*Preliminary Consultation*  
**MONTGOMERY COUNTY HISTORIC PRESERVATION COMMISSION**  
**STAFF REPORT**

<b>Address:</b>	23 Columbia Ave., Takoma Park	<b>Meeting Date:</b>	3/13/2019
<b>Resource:</b>	Contributing Resource <b>Takoma Park Historic District</b>	<b>Report Date:</b>	3/6/2019
<b>Applicant:</b>	Ruth & Karl Pitt Rick Vitullo, Architect	<b>Public Notice:</b>	2/27/2019
<b>Review:</b>	Preliminary Consultation	<b>Staff:</b>	Dan Bruechert
<b>Proposal:</b>	Garage Construction, New Windows, Doors, and Hardscape alteration

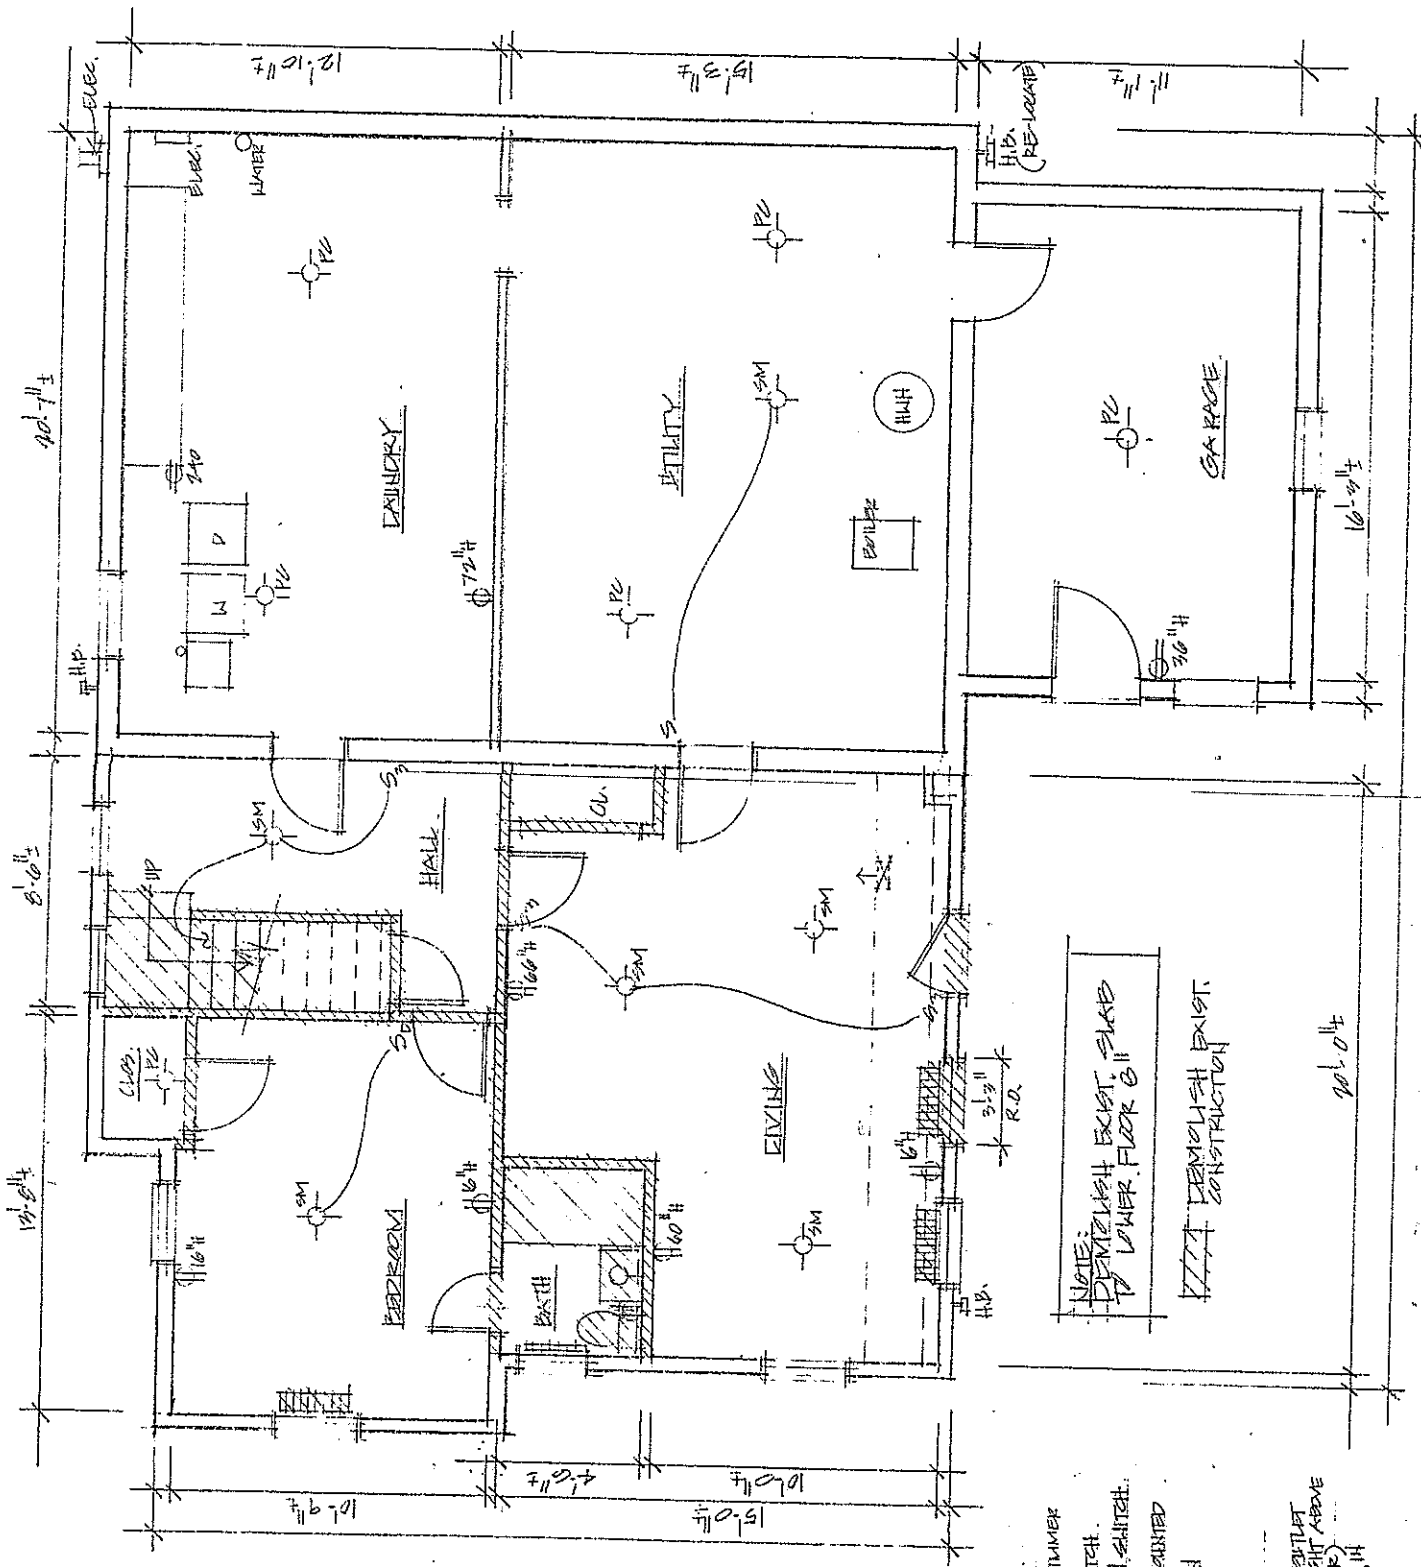
The applicant proposes to construct a new parking pad off of Columbia Ave., a new driveway apron off of Hickory Ave. and to construct a new concrete walkway around the property. The

new walkway will include a ramp to address the slope on the site and accommodate aging in place for the current owners. Based on the drawings it appears that a tree will need to be removed to accommodate the proposed paver driveway off of Columbia Ave. To date, Staff has not received an arborists report or a letter from the Takoma Park Arborist having reviewed this.

There are several front-loading driveways along Columbia Ave. including several parking pads. Staff finds that this proposal is not out of character with the surrounding district and thinks that the proposal is appropriate for the site and surrounding district. The only material specs provided for this proposal is “paver driveway.” Staff finds that most pavers would be appropriate in this location, as pavers would add texture to this new feature that is more consistent with the surrounding district. Staff recommends that a condition be added to this HAWP for the submission and review of the pavers selected for this proposal.

The applicant proposes to install a new concrete driveway to provide access to the new garage. The existing driveway is comprised of a concrete apron with a gravel driveway. The dimensions for the new driveway are almost exactly the same as the existing drive, in a different material. Staff finds that paving this new driveway could result in a significant change in character depending on the concrete mix and color selected. Throughout much of the Takoma Park Historic District, the sidewalks and driveways utilize concrete that was poured prior to WWII. This concrete has a darker color and includes some texture and exposed aggregate. However, all of the concrete sidewalks, curb cuts, and driveway aprons were replaced with contemporary, bright concrete. In this instance, a mottled concrete may actually stand out from the surrounding district. Staff finds that either type of concrete would be compatible with the historic resource and surrounding district as the character of the surrounding district has changed. Because the removal of a tree is required for this alteration, Staff request the applicant submit a letter from their certified arborist that the tree is “dead, dying, or an immediate hazard” or from the City of Takoma Park Arborist issuing preliminary approval for the tree removal.

Finally, the applicant proposes to construct a series of walkways around the property from the new front drive/parking pad to the side entrance, to the new garage at the rear. The walk will provide a ramp to navigate a significant grade change on the site. The walk will be 3’ 6” (three feet, six inches) wide and will be constructed out of masonry. Details for this masonry were not provided with the application materials; additionally, Staff is unsure if a railing will be required to accommodate the grade change. The applicants indicate that their desire for this new feature is to allow the owners to navigate the as they age-in-place. Staff finds that much of this new paving will be at or above grade and will not be significantly visible from the right of way. Staff request the HPC provide feedback about the appropriateness of new hardscaping and include recommendations for materials in these locations.

PROPOSED HICKORY AVE. ELEVATION

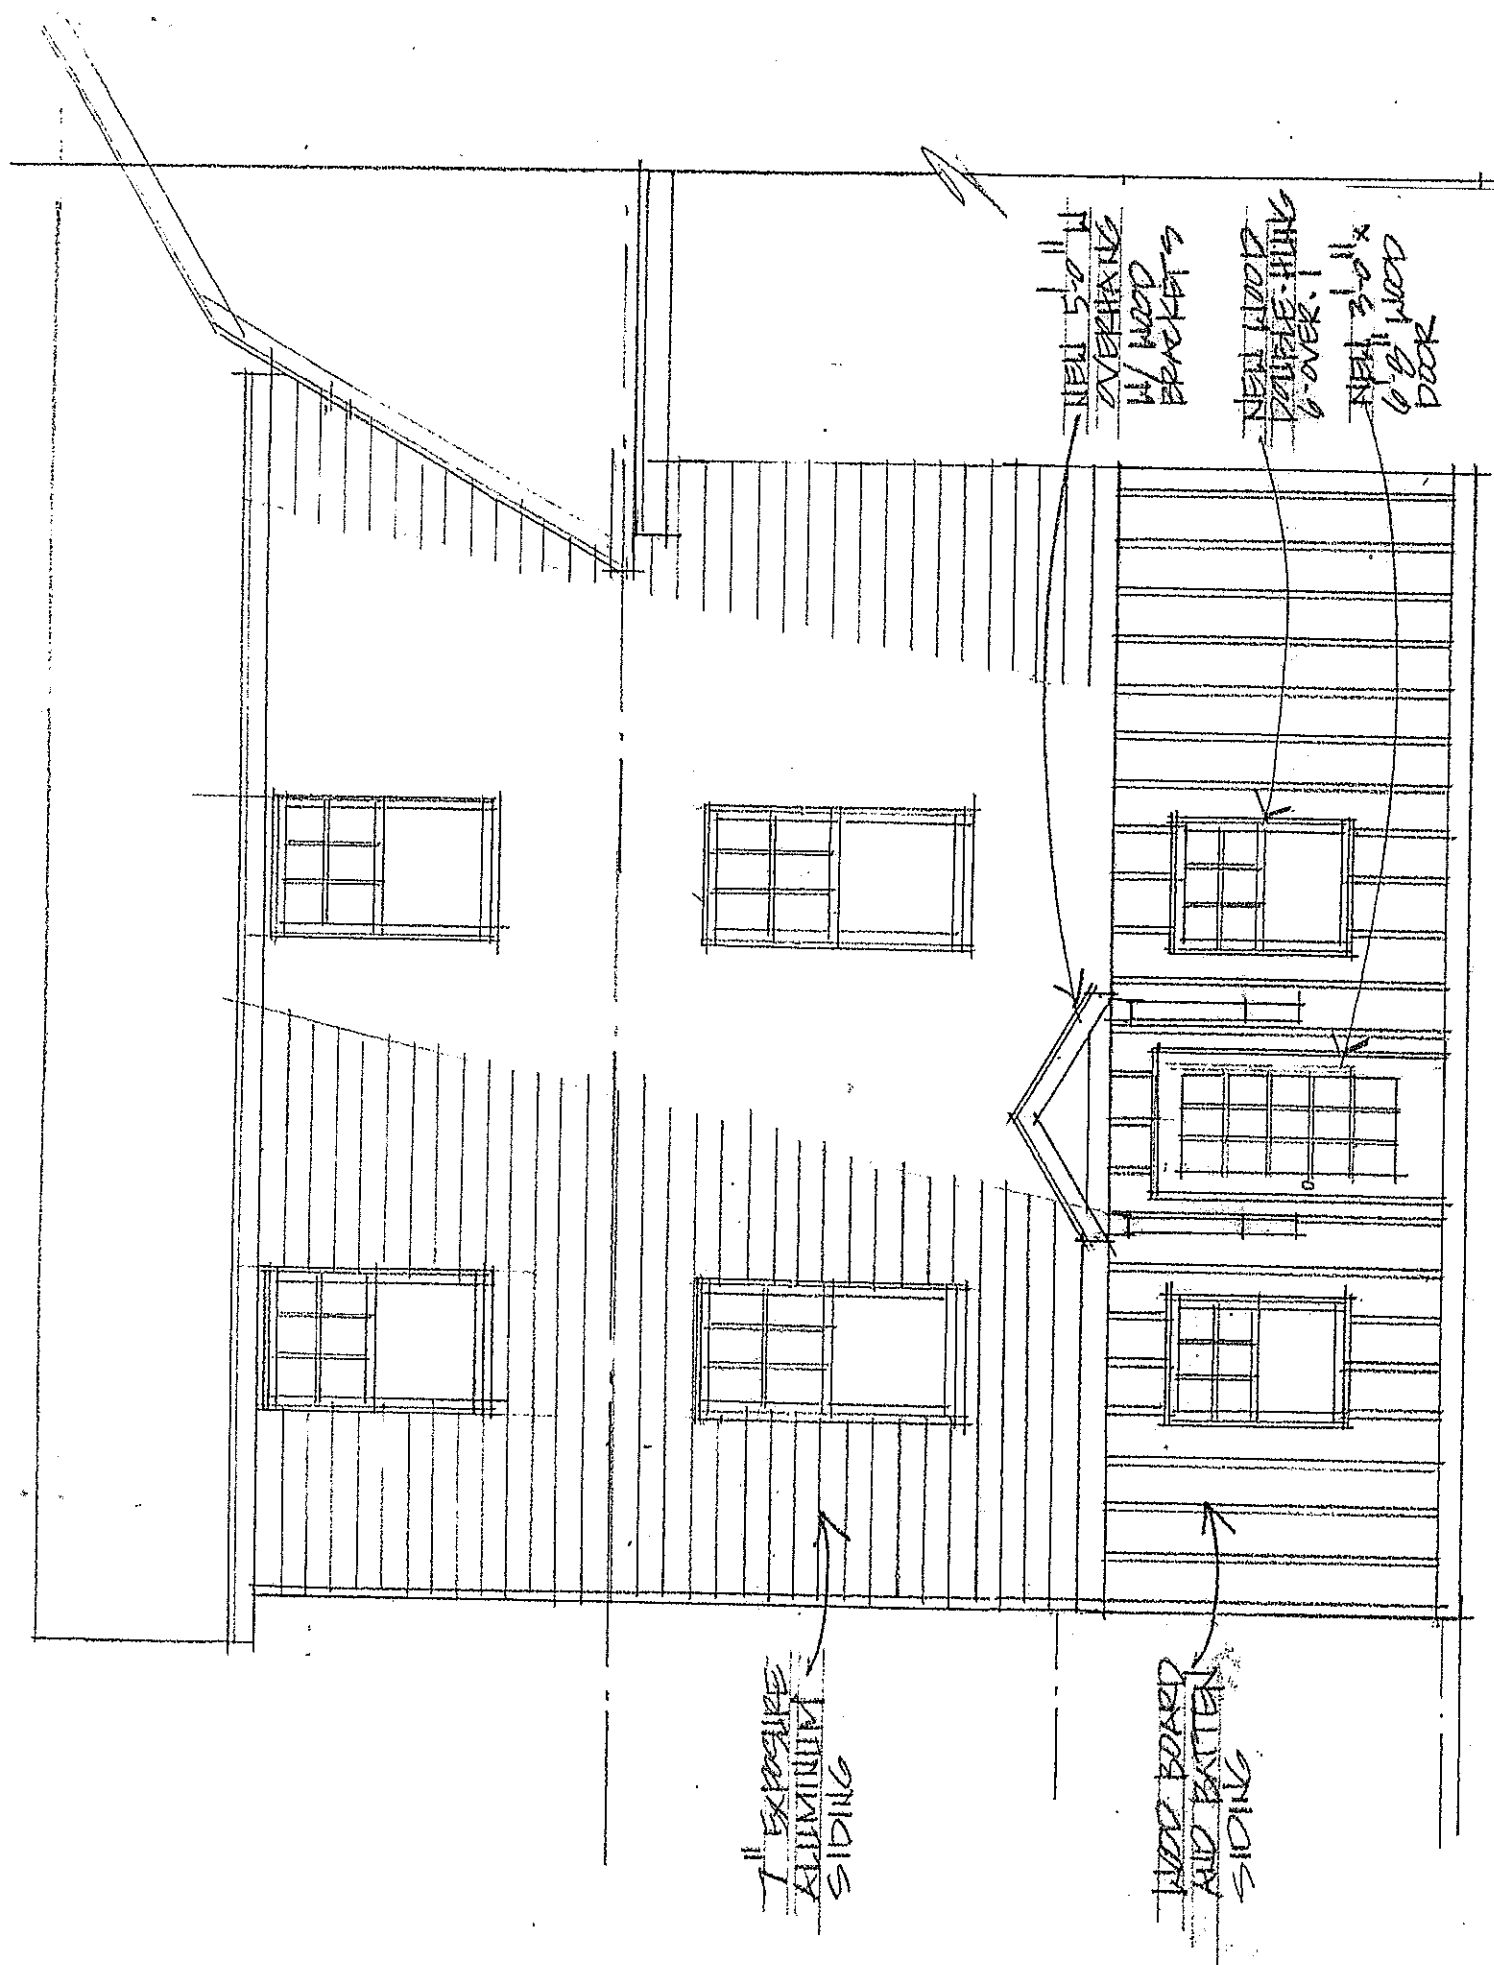
In the southwest corner of the house, there is currently a new basement level entrance covered by a simple pediment. There are two six-over-one windows to the left of the existing doors. Staff has evaluated the rear and believes that this construction is an addition but has been unable to determine the date of this construction.

The applicant proposes to reconfigure fenestration in the southwest corner of the rear addition. The applicant proposes to place the door in the middle flanked by a six-over-one windows. The new entrance will be covered by a wood, triangle pediment with wood brackets, similar in size to the existing overhang. The new window will be a wood, six-over-one window that matches the size and appearance of the existing window.

Staff finds that this will be a minor modification to the existing fenestration. Per the design guidelines, this alteration is generally consistent with the predominant architectural style of the house and Staff recommends approval of this change upon competition of the HAWP.
